Bid 658
Gym Bleacher Replacement Project for Adolfo Camarillo and Rio Mesa High Schools

BID CLARIFICATION ADDENDUM #1

Dated: January 16th, 2022

7 DETAIL

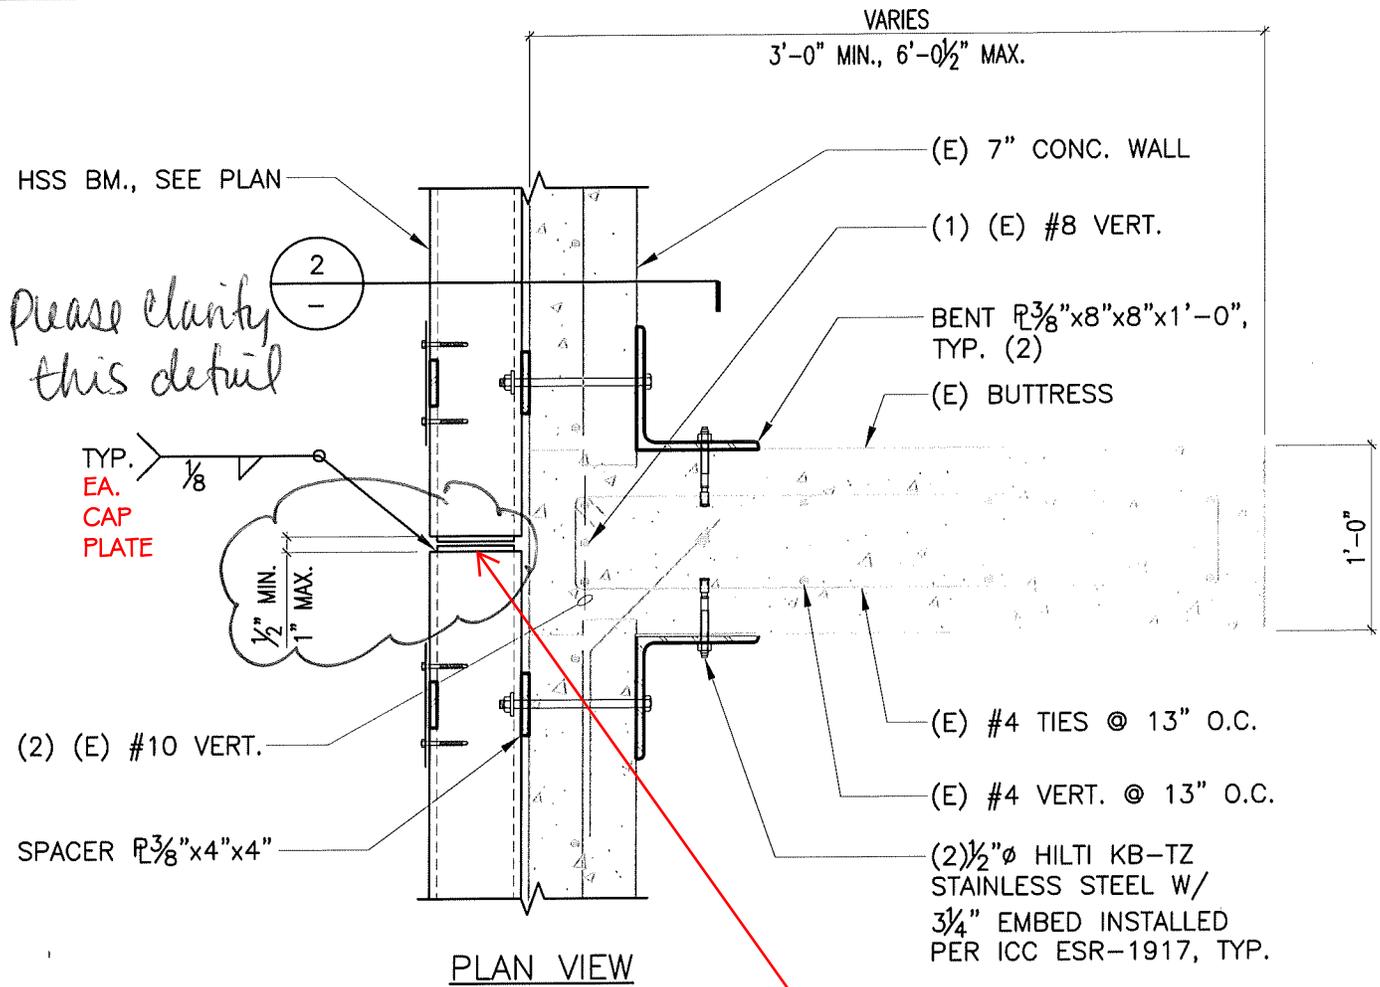
Can you please provide clarifications to the detail attached. The sleeve appears to be inside the HSS, but it is not clear.

please clarify this detail

Note: The above markup in red colored font was provided by Architect/Engineer.
